Work Order ID 102489

Item Name: Basket Hoop

DESIGN #	DRAWN BY CP	DART AEROSPACE LTD HAWKESBURY, ONTARIO, CANADA	
CHECKED #	APPROVED #	DRAWING NO. D3166	REV. A SHEET 1 OF 1
DATE 02.07.10		TITLE BASKET HOOP	SCALE NTS
A	02.07.10	NEW ISSUE	
A1	04.04.08	38+/- WAS 36.0

DRAWING NO. D3166	TITLE BASKET HOOP	REV A1	DART AEROSPACE LTD ENGINEERING ORDER		D.E.O. NO. D3166-A-2	SHEET NO. 1 OF 1	SCALE NTS
DRAWN AJS	CHECKED 1	MFG. APPR. M	APPROVED MP		DE APPR. M		
DATE 08.12.11	DATE 08.12.15	DATE 08/12/15	DATE 08/12/16		DATE 08.12.16

D3166-1 BASKET HOOP

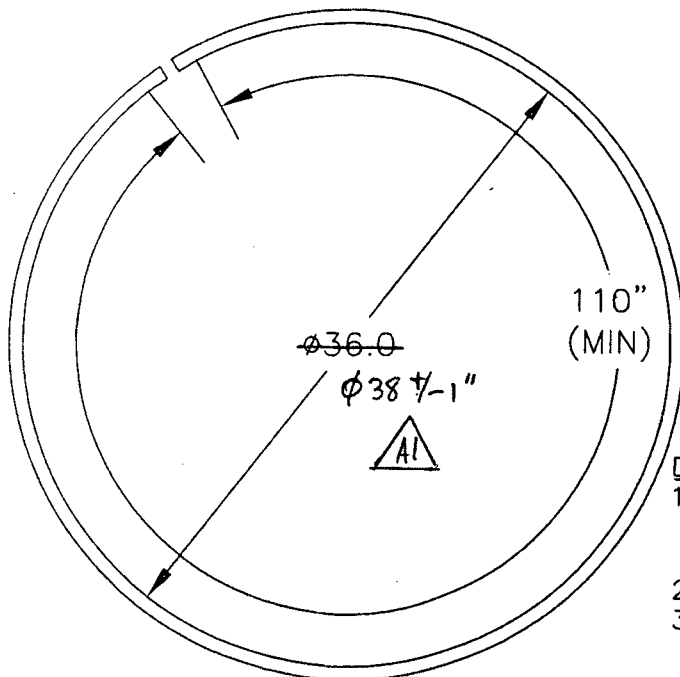
1) MODIFY MATERIAL NOTE FOR D3166-1 AS SHOWN:

WAS:

1) MATERIAL: AISI 304/316 SS SQUARE TUBING,
0.75" x 0.75" x 0.063 WALL, 60.00" LONG
(REF DART SPEC. M304TS0.750W.063)

2) MODIFY MATERIAL NOTE FOR D3166-3 AS SHOWN:

WAS:

1) MATERIAL: AISI 304/316 SS SQUARE TUBING,
0.75" x 0.75" x 0.063 WALL, 120.00" LONG
(REF DART SPEC. M304TS0.750W.063)

IS:

1) MATERIAL: AISI 304/316 SS, 3/4 X 3/4 X 0.065 WALL SQUARE TUBING,
60.00" LONG
REF. DART SPEC M304TS0.750W.065

IS:

1) MATERIAL: AISI 304/316 SS, 3/4 X 3/4 X 0.065 WALL SQUARE TUBING,
120.00" LONG
REF. DART SPEC M304TS0.750W.065
